# SAN FRANCISCO PLANNING DEPARTMENT

**DATE:** July 21, 2015  
**TO:** Adam Tartakovsky, 10 SVN, LLC  
**FROM:** Lisa Gibson, Planning Department  
**RE:** PPA Case No. 2015-004568PPA for 10 South Van Ness Avenue

## Preliminary Project Assessment

*Date:* July 21, 2015  
*Case No.:* **2015-004568PPA**  
*Project Address:* 10 South Van Ness Avenue  
*Block/Lot:* 3506/004, 003A  
*Zoning:* C-3-G (Downtown-General) District  
Van Ness & Market Downtown Residential SUD  
120-R-2 and 120/400-R-2 Height and Bulk District  
*Area Plan:* Market and Octavia Area Plan  
*Project Sponsor:* Adam Tartakovsky, Crescent Heights – (415) 527-9742  
atartakovsky@crescentheights.com  
*Staff Contact:* Melinda Hue – (415) 575-9041  
[Melinda.Hue@sfgov.org](mailto:Melinda.Hue@sfgov.org)

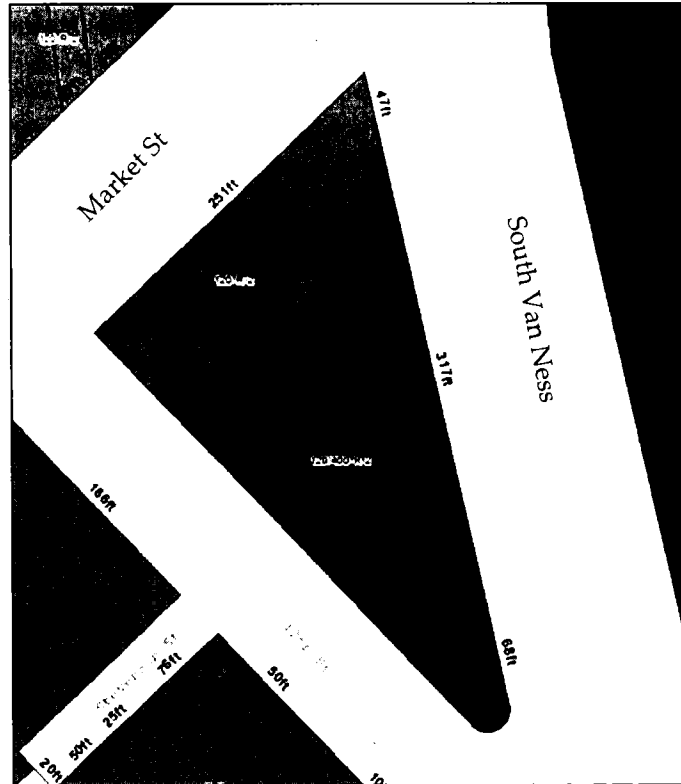
2. **Height.** Multiple Height and Bulk Districts apply to the project site. The northern portion of site is zoned 120-R-2 (with a 120' height limit), and the southern portion of the site is zoned 120-400-R-2 (120' podium height, with a tower of up to 400' in height). Portions of the northern tower are located within the 120-R-2 District, and exceed the allowable height for this District. The boundaries for the 120-R-2 District on the subject block are shown below:

In addition, the sloping parapets of both towers reach a maximum height of 440 feet, exceeding the allowances for features above the roof height limit described in Section 260(b). The project would need to be redesigned to comply with the applicable height limits, or the project sponsor would need to pursue Legislative Amendments (Height Reclassification and General Plan Amendments) in order to proceed as proposed. It should also be noted that the project does not comply with the tower separation requirements applicable to the 120-400-R-2 Height and Bulk District, as discussed below.
